## Plan Changes to Countermeasures against the Fracture of Moving Vane Mounting Assembly in the Hamaoka Nuclear Power Station Unit 4 Low-Pressure Turbine

Changes in the blade groove shape of the moving vane mounting assembly (shaft side) (12th stage as an example)

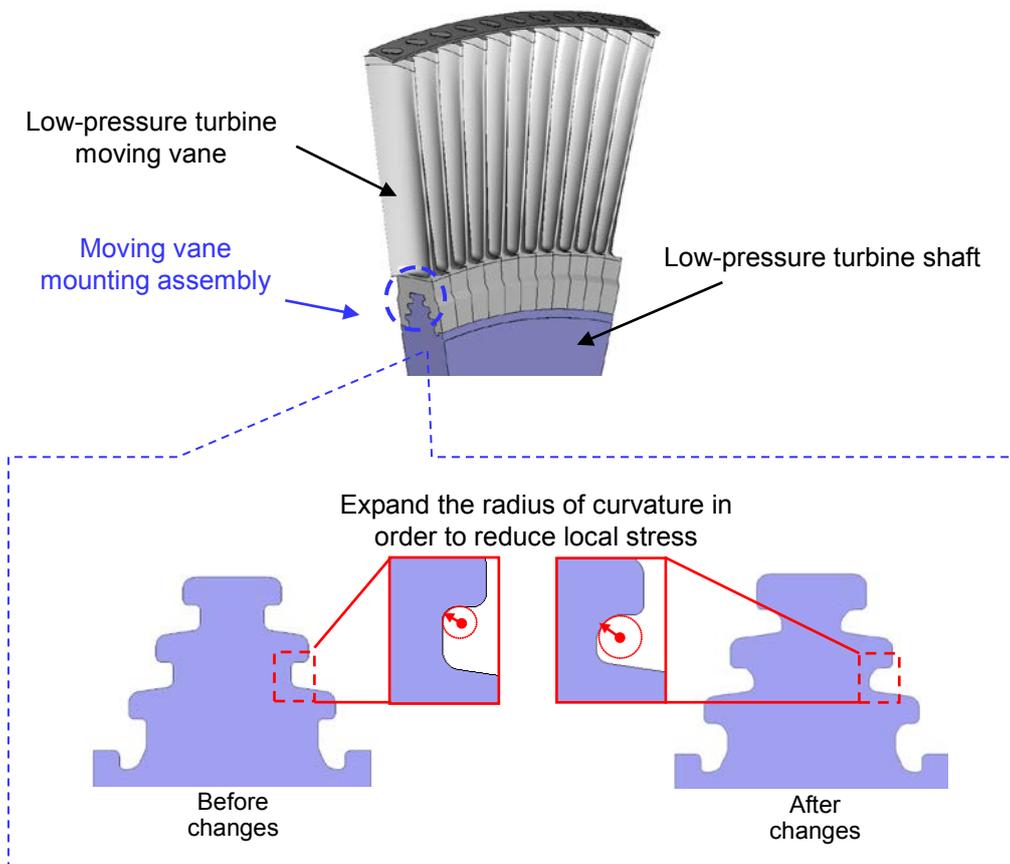
For the 10th to 12th stages of the Unit 4 low pressure turbine (A) - (C) in which fracture was confirmed due to stress corrosion cracking, stress concentration will be mitigated by increasing the radius of curvature regarding the hooked root of the moving vane mounting assemblies (on the shaft side).
